STATE OF WASHINGTON
DEPARTMENT OF ECOLOGY

Re: Comments on revised draft Sundberg Gravel Pit Data Gap Report and Remedial Investigation Work Plan

- **Site Name:** Sundberg Gravel Pit
- **Site Address:** 2200 Cooper Pt Rd, Olympia, Thurston County, WA 98502
- **Facility/Site ID:** 82016954
- **Cleanup Site ID:** 10635

Revised Figure A2

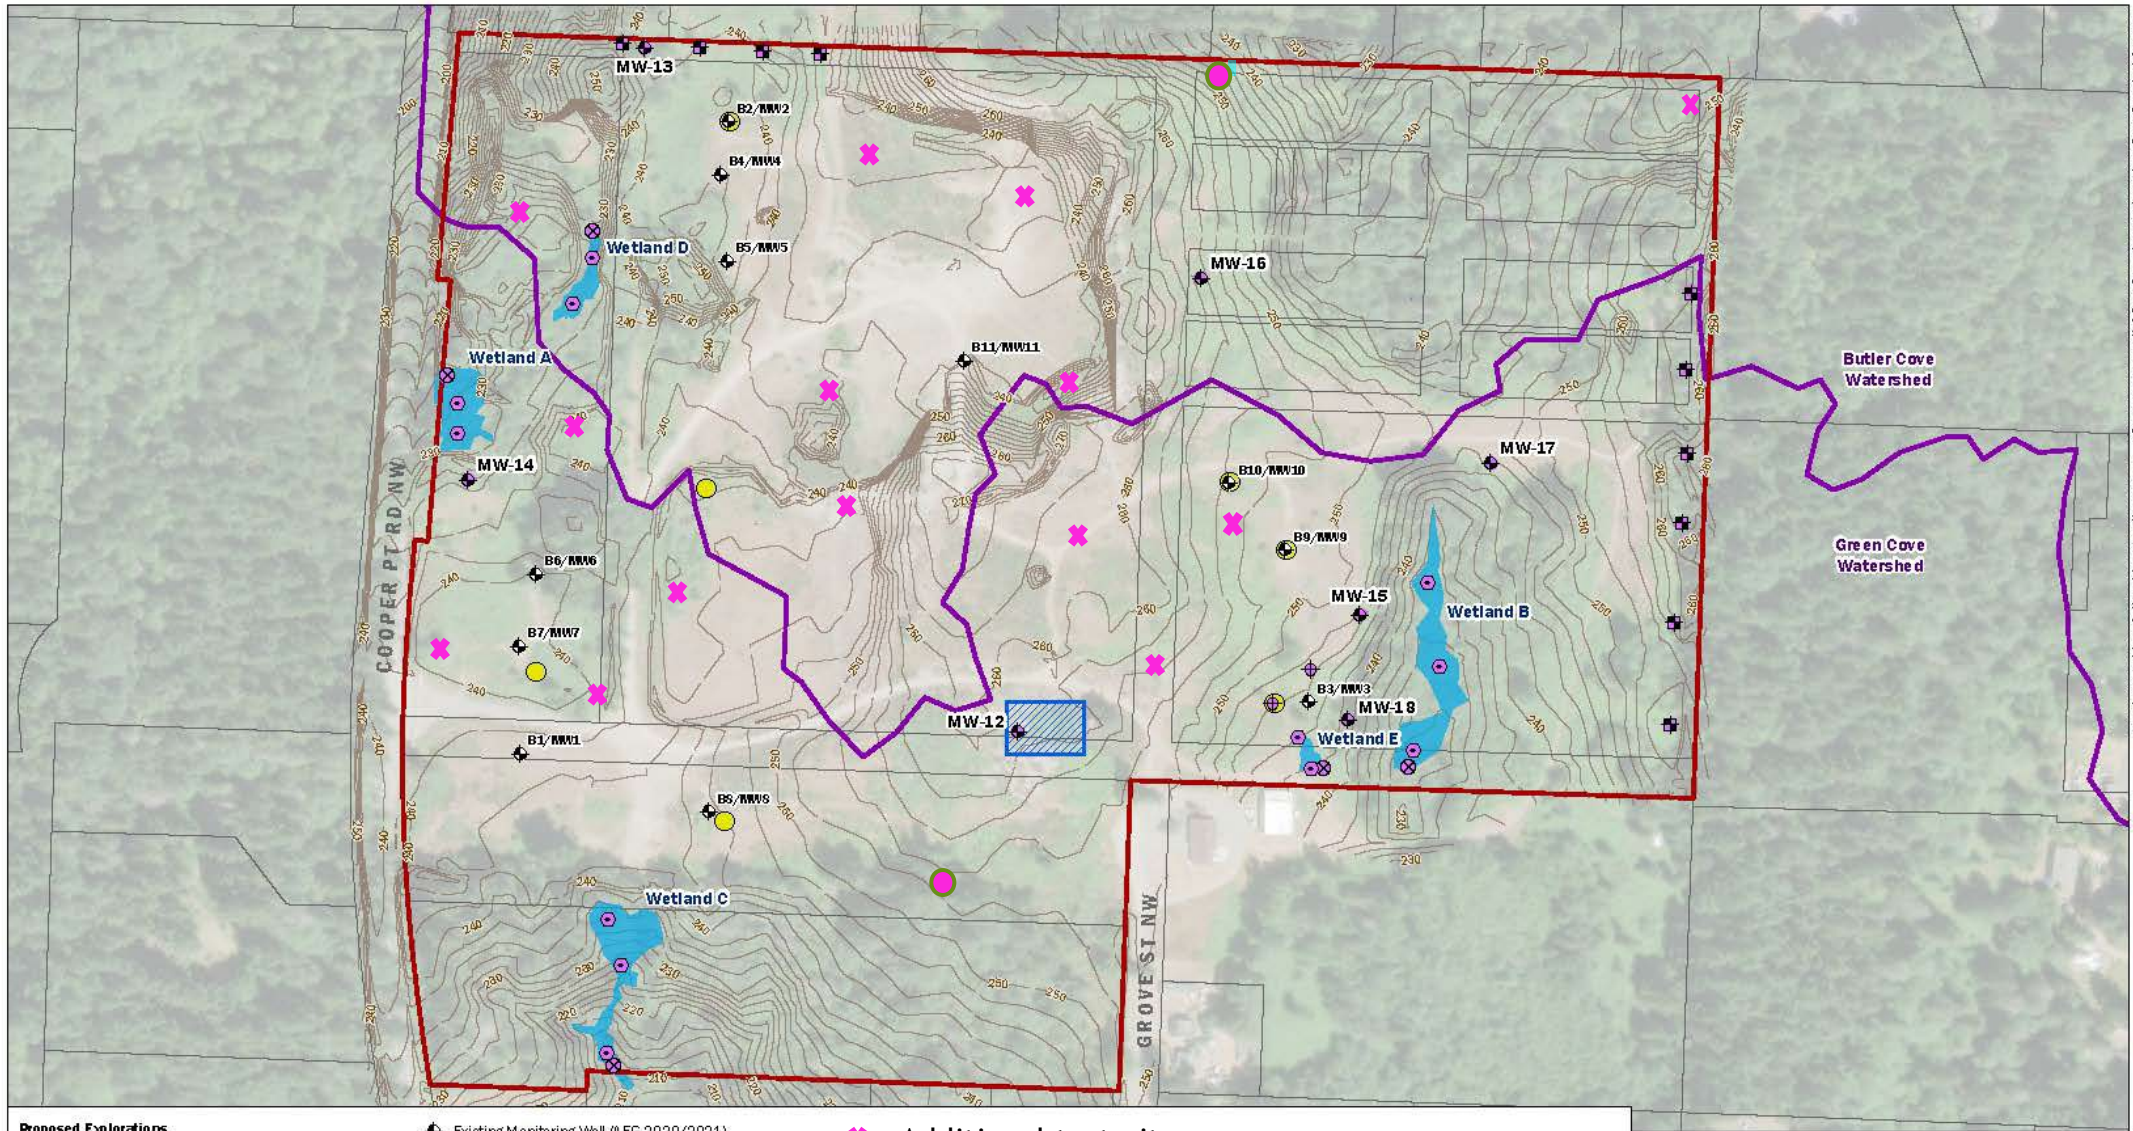
contaminants from fill to groundwater by evaluating groundwater downgradient of areas with unknown depth of fill. Without understanding the depth and quality of fill and shallow groundwater across the Site, it is not possible to confirm the appropriate locations and depths for downgradient groundwater sampling. Ecology has identified areas of the Site where additional investigation into fill is needed (See Enclosure A).

The approximate location of this test pit is shown on Enclosure A.

To understand the groundwater quality, depths, divide(s), groundwater flow directions, and gradients, Ecology requires two additional groundwater monitoring wells, in addition to those already proposed in the Work Plan, near the north and south borders (See Enclosure A).

- **Install one groundwater monitoring well along the north-central border, north of test pits TP21 and P6, where fill was observed and where reports of buried garbage and metal drums occurred.**
- **Install another groundwater monitoring well along the south-central border of parcel C (74202500200) between Wetland C and Grove St NW to evaluate groundwater quality, depth, flow direction and gradient to the south of known fill areas.**

- **Include a phased approach plan, including test pits and boring, as described in the phased approach plan along the eastern border, to investigate the fill in these locations.**

- **To the phased sampling approach along the eastern border of the property, add a test pit in the northeast corner of the property where land disturbances are noted in aerial photos from 1960 and 1965 and fill was found in test pits TP24 and P5.**
